# SERVICE BULLETIN

Number: 13-002

## Ford 5.4L / 6.8L Mount Kit Safety Recall

**View from front of engine with the tangs improperly located to the front of the engine (without mount, compressor, or alternator)**

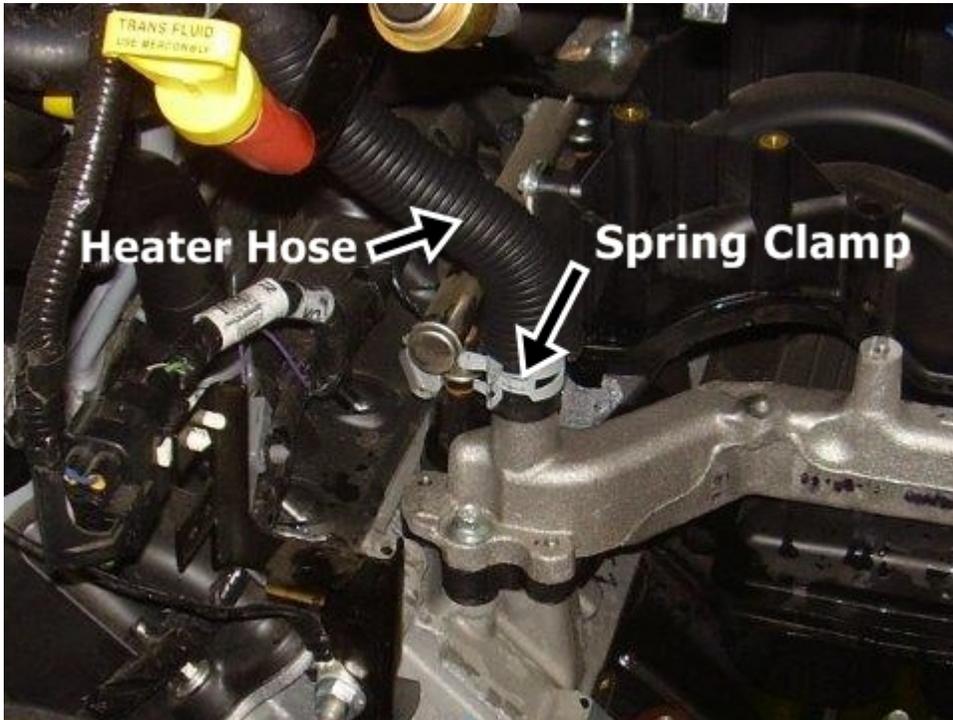
If the tab from the heater hose spring clamp is not oriented properly, (toward the rear of the engine) it could possibly pinch the alternator cable against the compressor mount plate.

If the harness is pinched, move harness to a location that is clear of spring clamp and rotate the tangs of the clamp to the rear of the engine (See pictures below)

**View from front of engine (without compressor)**

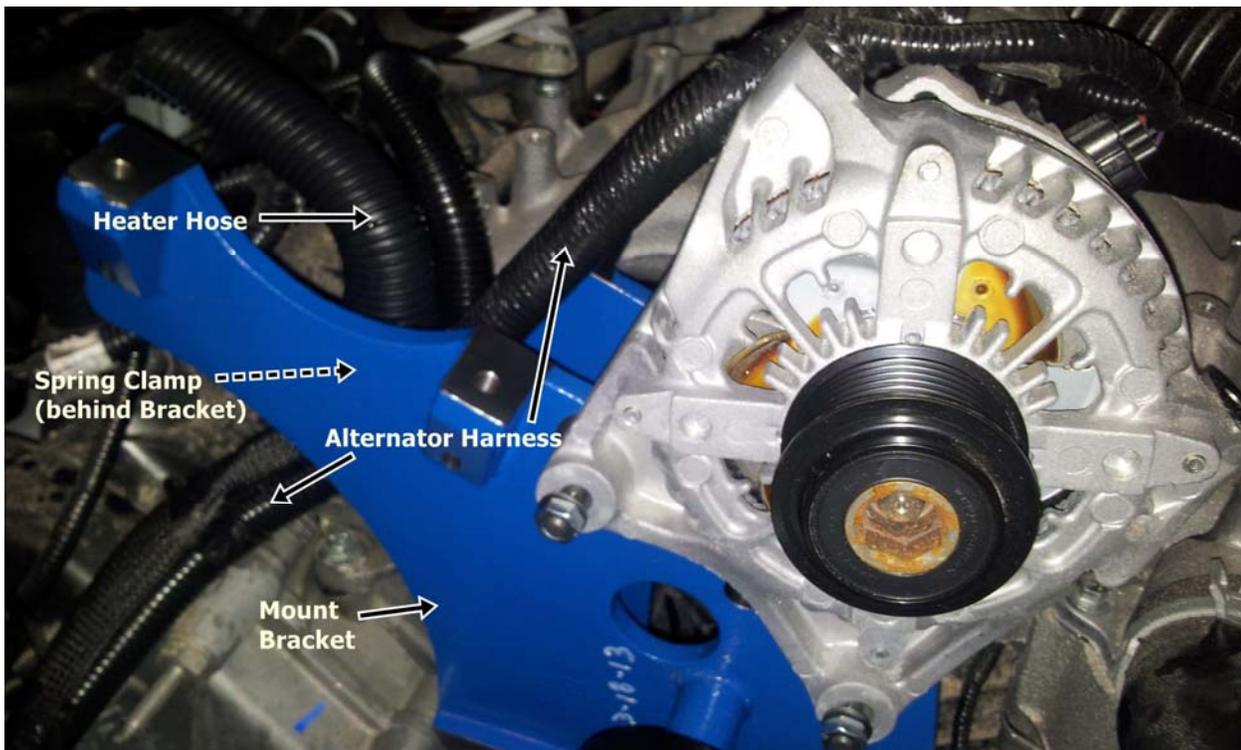
Inspect the alternator harness to be sure it is not pinched between the spring clamp and the compressor mount plate, while at the same time verifying the tabs on the clamp are oriented toward the rear of the engine.

1. Reach behind the compressor and move the alternator cable up and down
2. If it moves without binding and you have verified that spring clamp tangs are oriented properly, to the rear of the engine, the vehicle is OK.

3. If the harness does not move, feel to see which way the spring clamp tangs are oriented. If the tangs are oriented properly, vehicle is OK.
4. Submit warranty claim to Trans/Air Mfg. for this inspection using MK-10-A flat rate code.

5. If the harness does not move, and if the tangs are not oriented properly, follow instructions below:
  - a) Remove compressor belt
  - b) Loosen the compressor from the mount bracket

- c) Lay the compressor to the left side of the bracket
  - d) Loosen the mount bracket enough to free the harness
  - e) Rotate the spring clamp on the heater hose, until the tangs are facing the rear of the bus

- f) Inspect harness for damage and repair if necessary
  - g) Contact Trans/Air Warranty for authorization if repair is necessary
  - h) Tighten the mount bracket

- i) Re-check to make sure the harness is not binding or pinched
  - j) Mount the compressor back into the bracket
  - k) Re-install belt
  - l) Submit warranty claim to Trans/Air Mfg. for this inspection using MK-45-A flat rate code
